**Consumers
Power
Company**

September 28, 1982

DOCKET 50-155 - LICENSE DPR-6 -
BIG ROCK POINT PLANT -
FIRE PROTECTION

RESPONSE TO STAFF POSITION
ON CERTAIN ISSUES OF PLANT
ALTERNATE SAFE SHUTDOWN DESIGN
NRC LETTER DATED APRIL 30, 1982
ENCLOSURE 2

Figure 1. Temperature and concentration limits for caustic cracking of type 304, 347, 316, and 321 stainless steels. (After Speidel.)

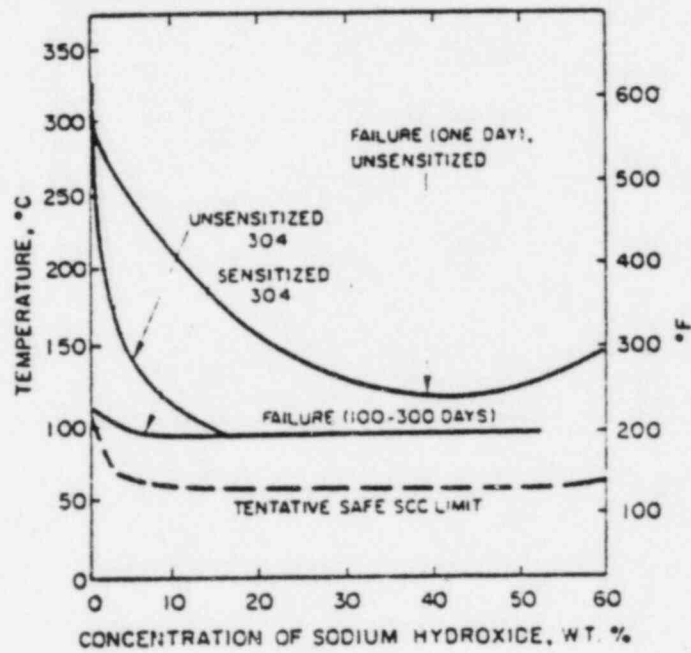
All referenced test data were at or above typical PWR steam generator operating temperatures (600° to 630°F). The maximum temperature that could be reached in the BRP emergency condenser would be 613°F (for approximately five hours)(2) on the tube condensing side and much less on the shell (lake water) side. The tendency for caustic cracking is known to decrease with decreasing temperature (Figure 1).(7)

Figure 2

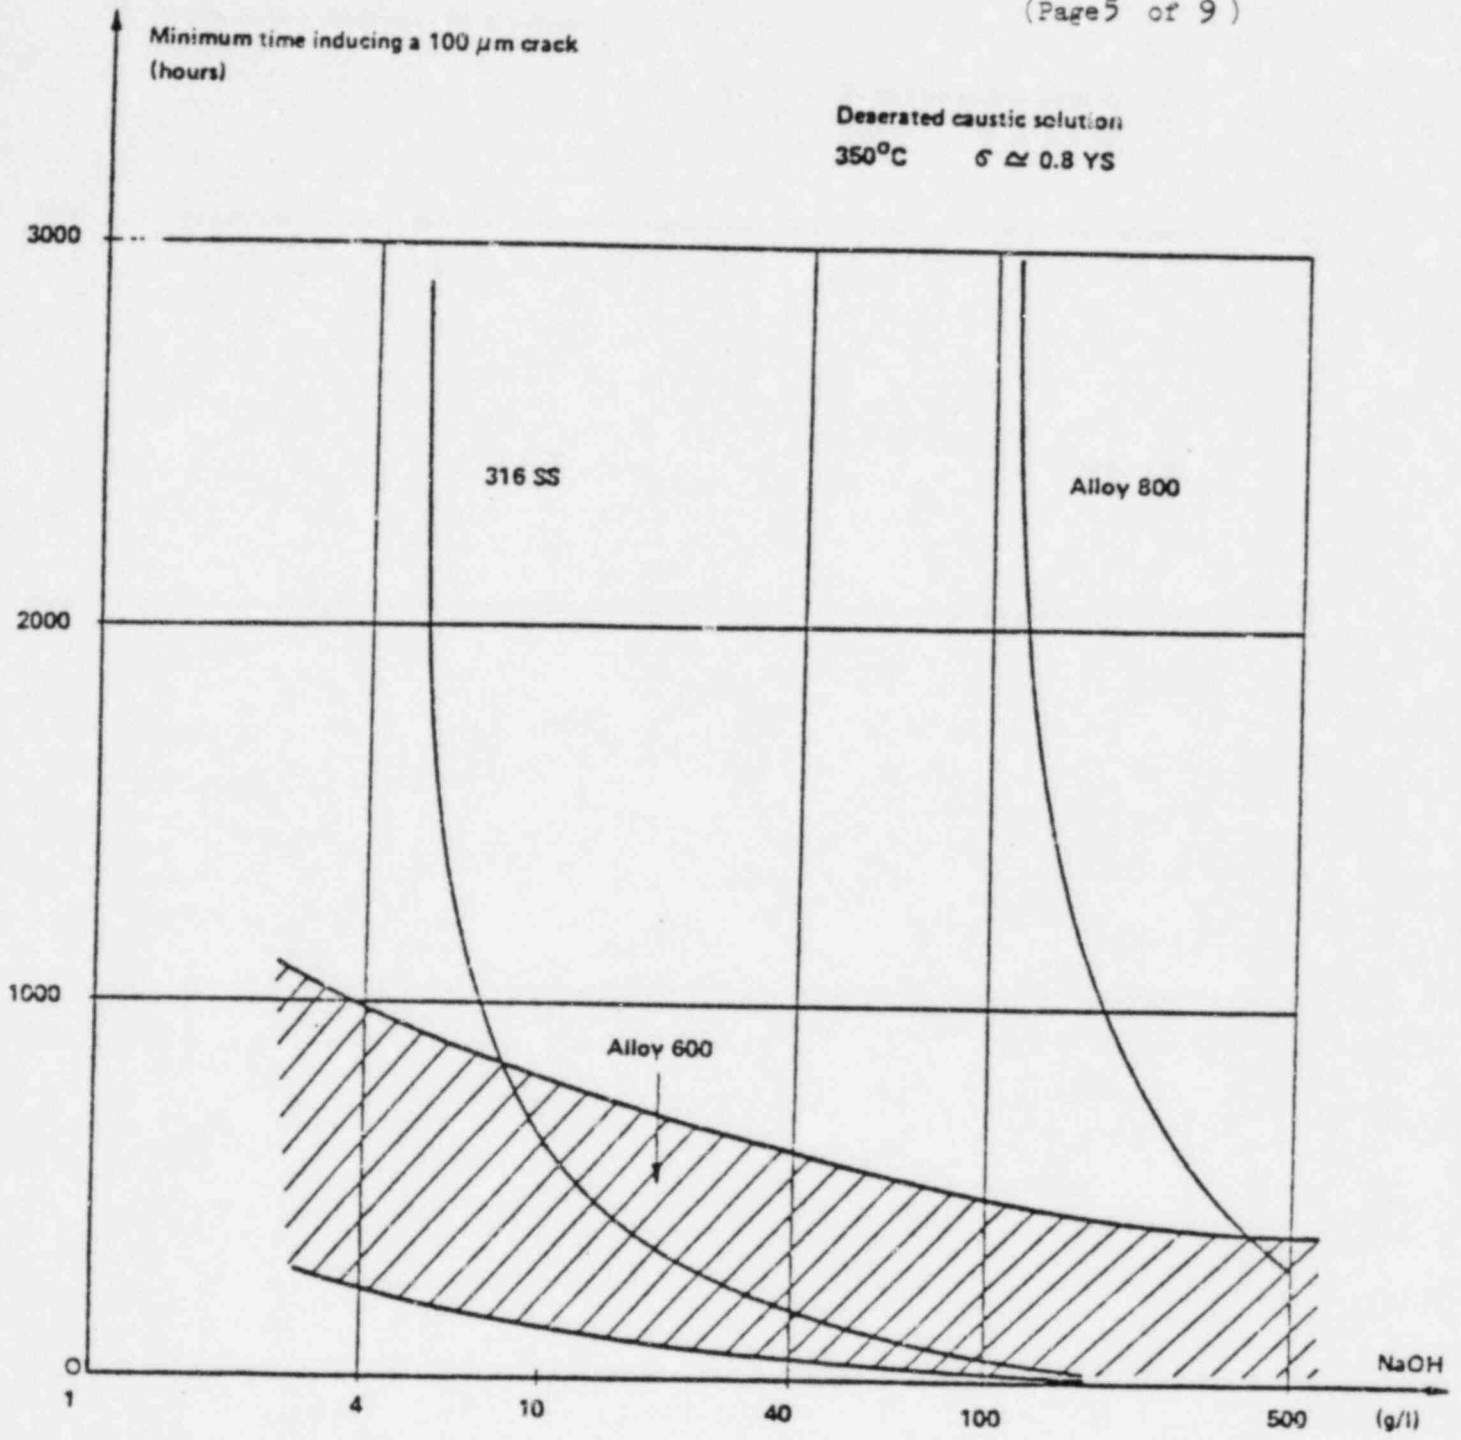
the emergency condenser. Berge, et al(9) found that caustic attack of Type 316 stainless steel was not a problem below a 0.5% NaOH concentration (Figure 2). Above that concentration, the NaOH concentration had a strong influence on the rate of caustic attack. Such behavior was summarized by Speidel(7) who also considered temperature (Figure 1). It can be seen that in the worst case, failures would be in the 100- to 300-day category at an NaOH concentration < 1%.

Figure 1 Variation of OH⁻ ion concentration upon concentrating Lake Michigan water by steaming at 100°C

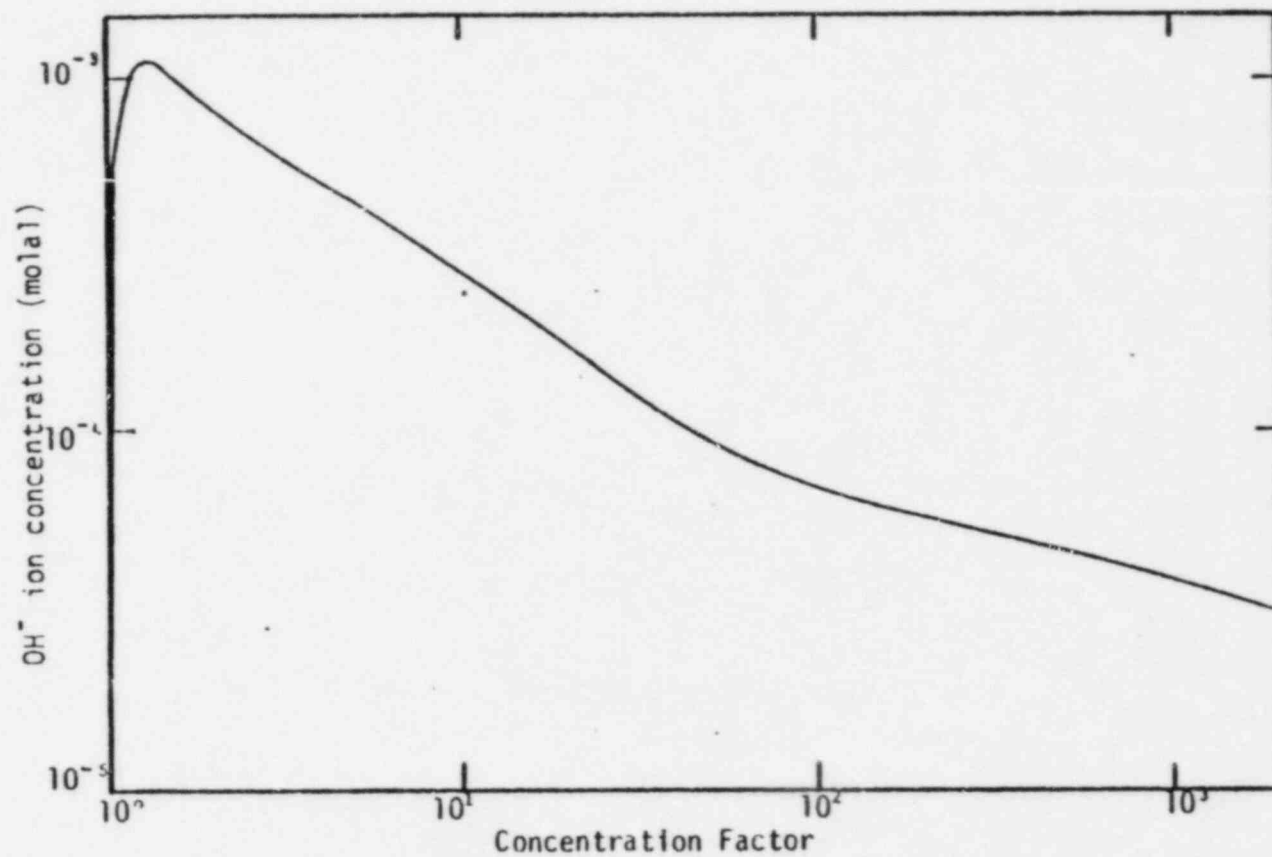
Assuming interactions with silica are negligible, the calculated variation of the OH^- ion concentration upon concentrating the solution by steaming is shown in Figure 1 as a function of the concentration factor, CF, defined as the ratio of the mass of water considered (in liquid and steam phase) to the mass of water in the residual liquid phase. It is seen that after reaching a maximum OH^- ion concentration of 0.001 molal (equivalent to 40 ppm NaOH), the solution becomes less basic. Such behavior is qualitatively different from that predicted in a steam generator crevice with Lake Michigan cooling water ingress. (1) The difference can be understood as follows:
